Closeout Report

Technical, Cost, Schedule, and
Management Review

B PHYSICS at the TEVATRON (BTeV) PROJECT

April 29, 2004

Schedule

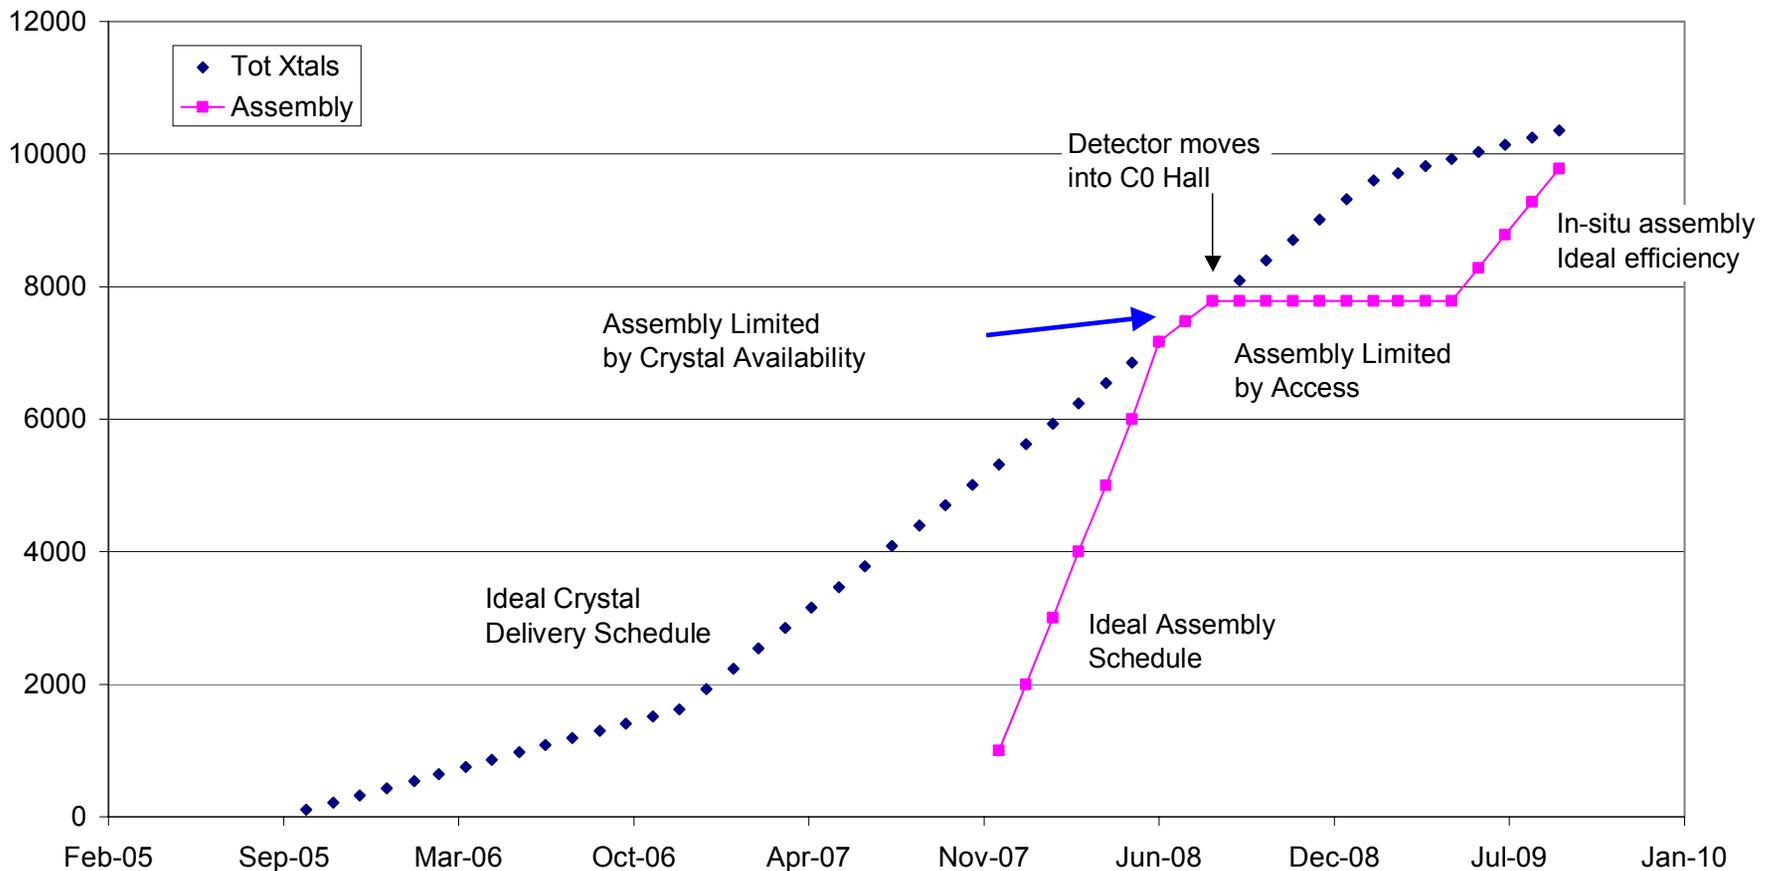
Schedule is very tight
